6673A-07A

S E R V I C E N O T E

6673A DC POWER SUPPLY GPIB CONTROLLED

The Current Shunt (Circuit Reference “R907”) may have intermittent sense wires, which may cause Instability of Current regulation, Current read back and Current programming.

A6 Output Assembly for Models (65/6673A, 74A, 75A & E4356A)

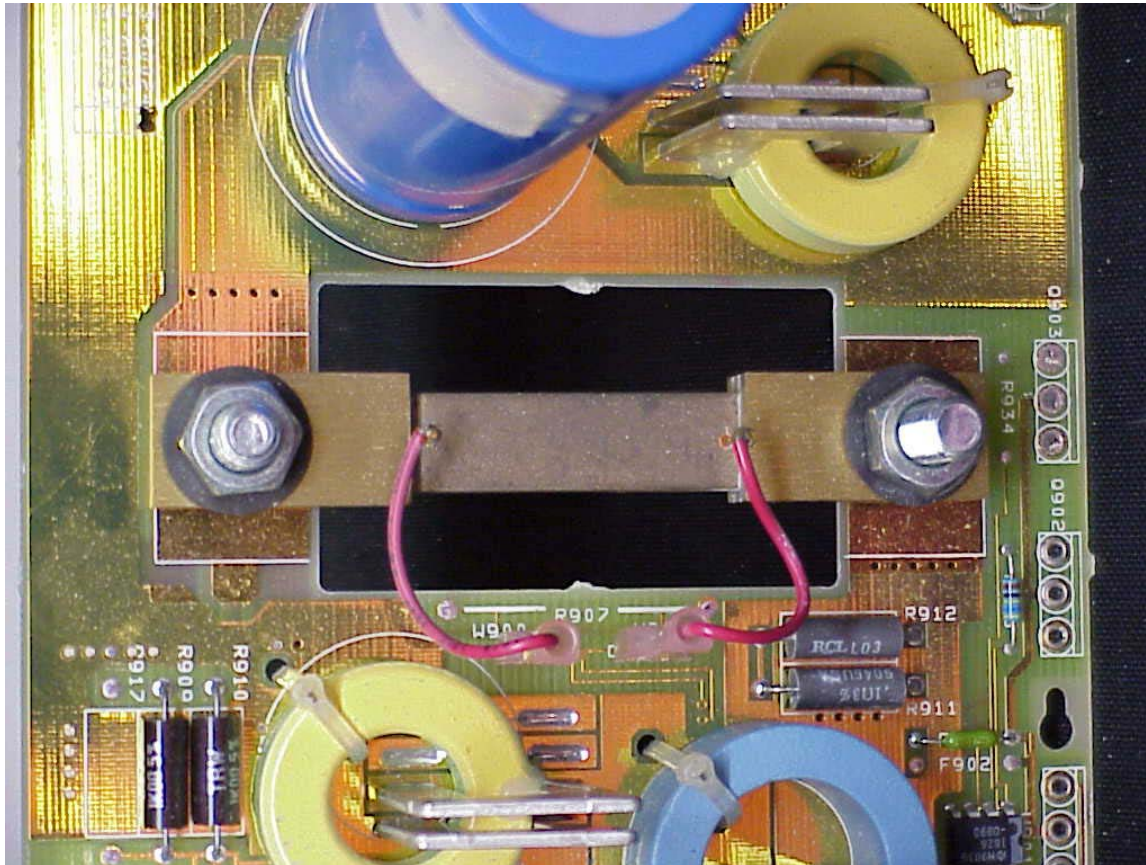
When the push-on connectors become intermittent the output current will become unstable. Loose push-on connectors can cause the output current to change dramatically. The current can change from any set current, and may go to the maximum rated output current of the instrument.

This picture shows how the Shunt R907 is connected using the term-crimp connectors.

The Shunt R907 is connected to "W900" & "W901"

Cut the terminal-crimp connectors off of both wires and discard the connectors. Make this cut as close to the terminal-crimp connector as possible. The required strip length should be 5mm. This strip length will be used to prevent the wire length being too long and shorting to the instrument chassis. If replacement of this wire is required any color (22 AWG, 300V 105C) wire type can be used.

This modification can be done from the top of the board. Carefully strip and solder the wires, and avoid burning the wire insulation and the printed circuit board.

The wires should be connected as shown below. There are two holes marked R907 that should be used. Do not cross the wires when making this modification. See picture below for details. This picture shows the required modification.
